Staff Report to the  
Southeast Town Design Review Committee  
July 14, 2016

MPL2016-00031  
ITEM #4

## THE DISTILLERY

Specific Parcel Master Plan (SPMP) approval for 11-story, mixed use development with 28,000 SF ground-floor commercial, 151 dwelling units, and 295 space parking structure (3 stories).

# PROPOSED SITE PLAN

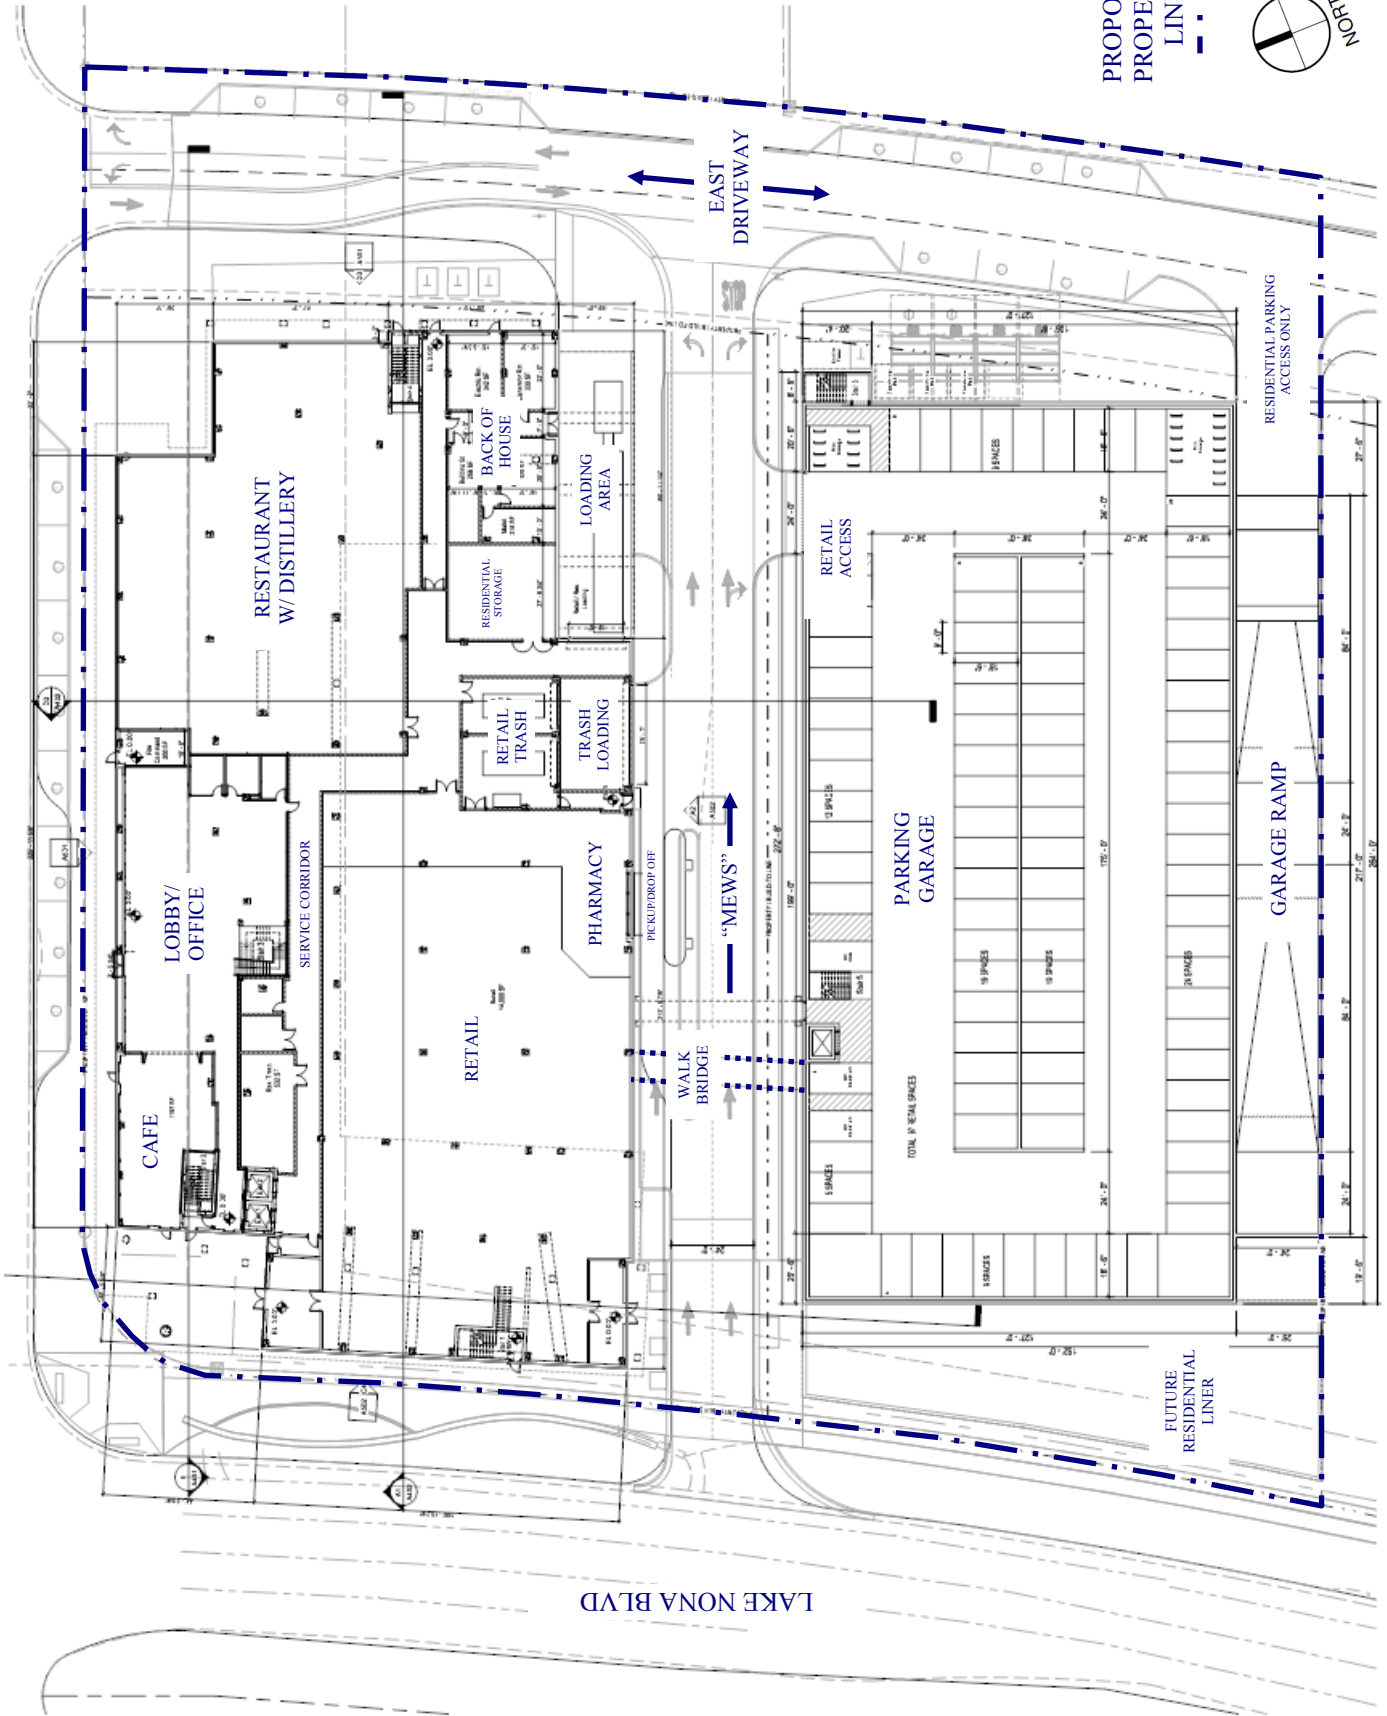
According to the Lake Nona Mixed Use District Plan, the maximum setbacks for Parkways vary by product type and are determined during SPMP review. The applicant submitted a site plan that shows a “build-to-line,” or the line at which construction of the building facade is to occur on the lot, and the property line. Table 3 summarizes the required and proposed setbacks for the subject project. Please note that the side yard setback (along the east driveway) has been determined using the “build-to-line.” Moreover, staff is requiring the rear property line be established a minimum 10 feet south of the garage structure with 7.5 feet of landscaping buffering.

The applicant shall establish a southern property line no less than 10 feet setback from the proposed garage structure. Additionally, the southern facing façade shall require a minimum 7.5 feet of landscaping buffer.

# SECOND FLOOR OF PARKING GARAGE

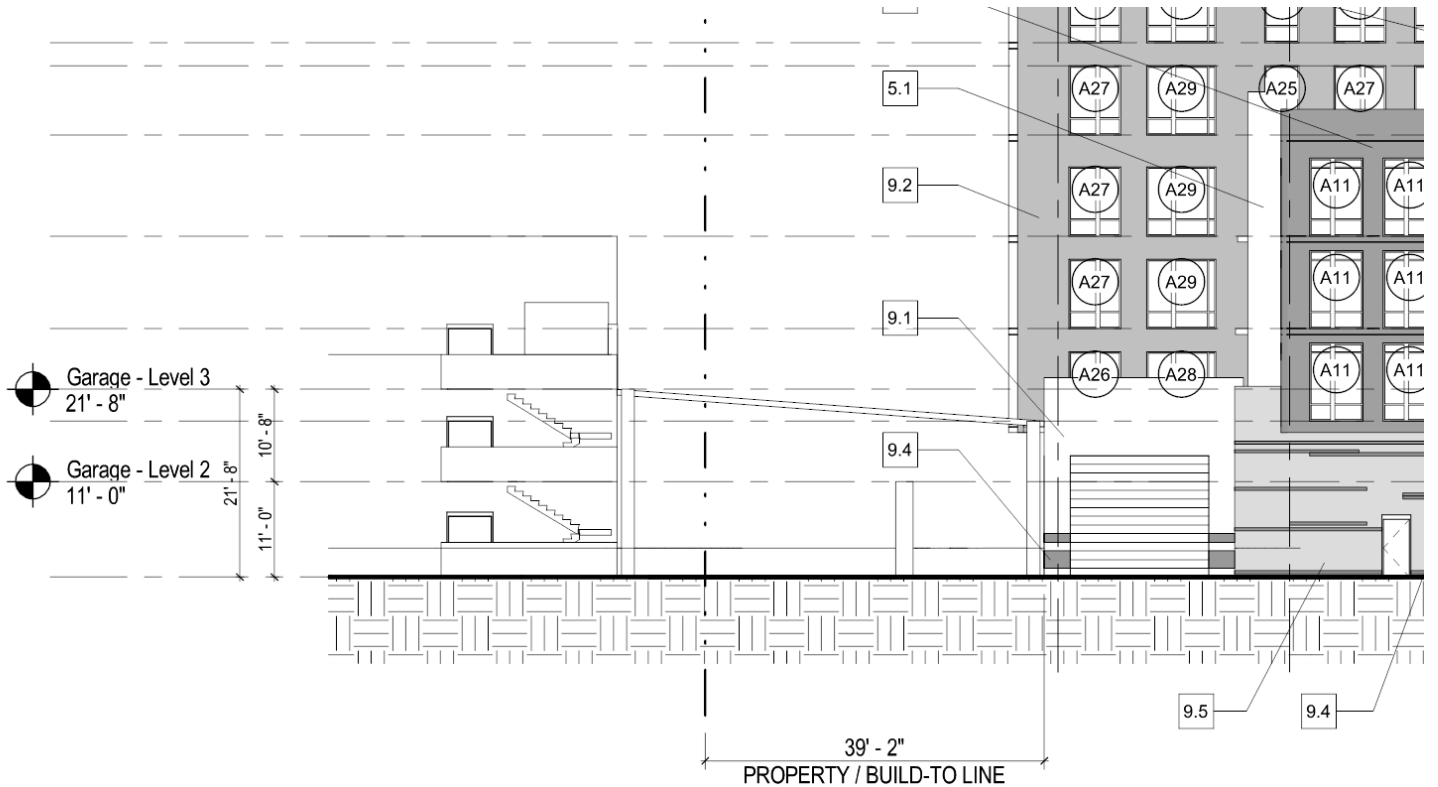
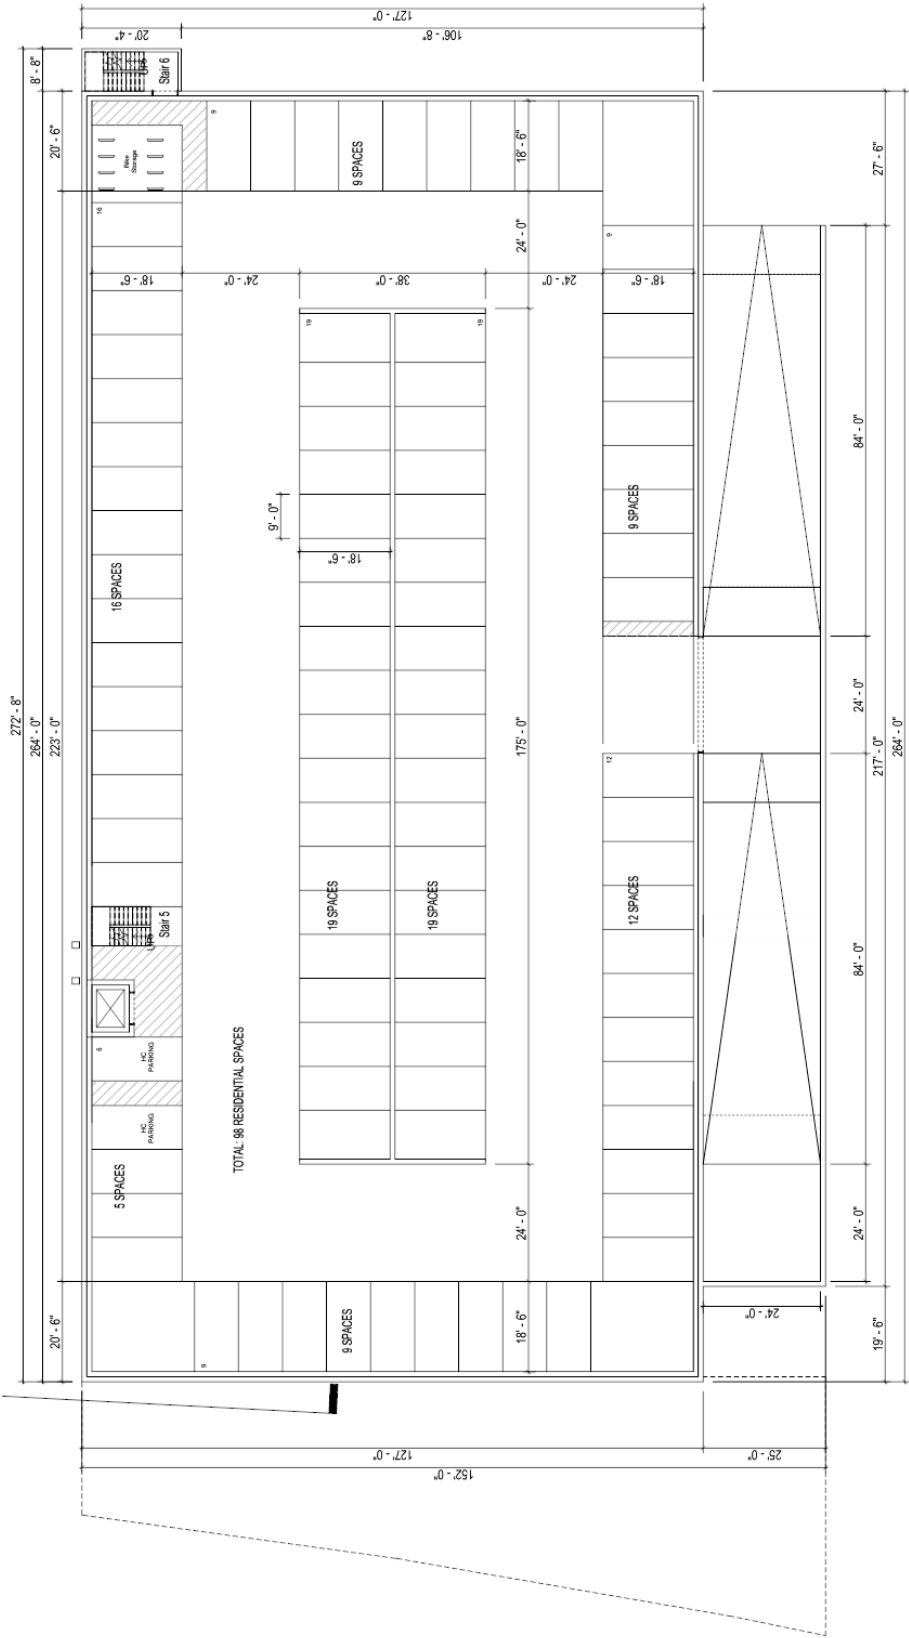
Garage must be redesigned to meet the minimum residential parking requirement on page 6.

Number of spaces indicated on this document do not meet the minimum required number of parking spaces per City Code Ch 61 and 68. The garage shall be redesigned to meet the minimum residential parking requirement.

# CONCEPTUAL LANDSCAPE PLAN

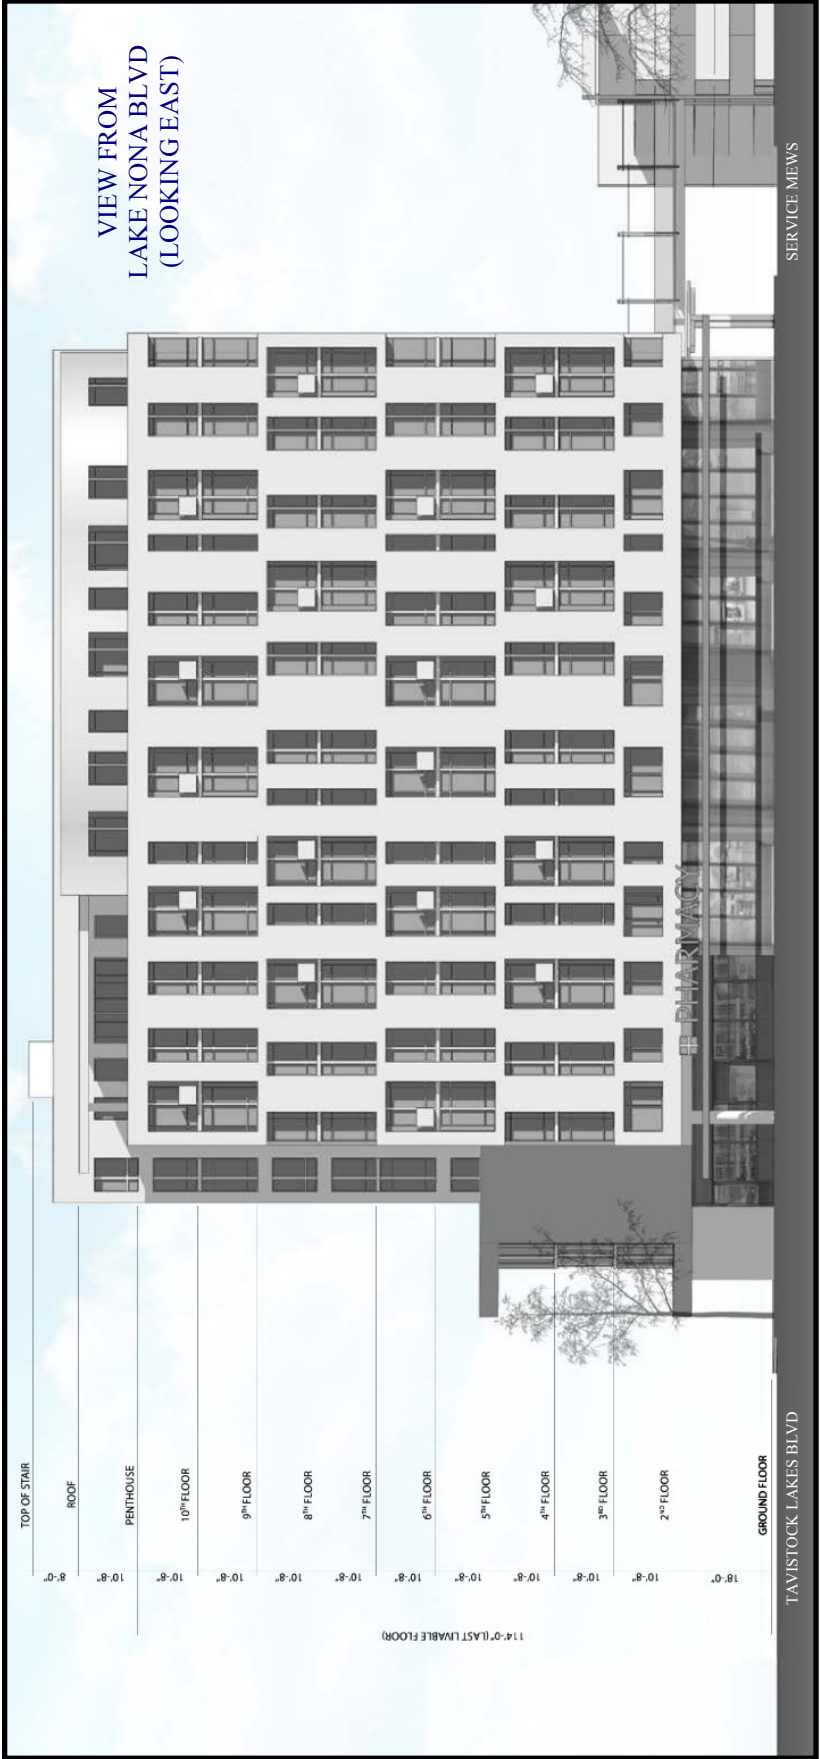
The applicant has submitted a conceptual site plan shown on **page 8**. A final landscape plan is required prior to the issuance of building permits and shall be developed in accordance with Chapter 60 and Chapter 61 Part 3B of the LDC as it deals with Landscaping for Parking Lots and Garages. Extensive screening will be required along the west and south sides of the Parking Garage.

The landscaping plan shall be developed in accordance with LDC Chapter 60 and is subject to appearance review via a Planning Official Determination, prior to the issuance of building permits.
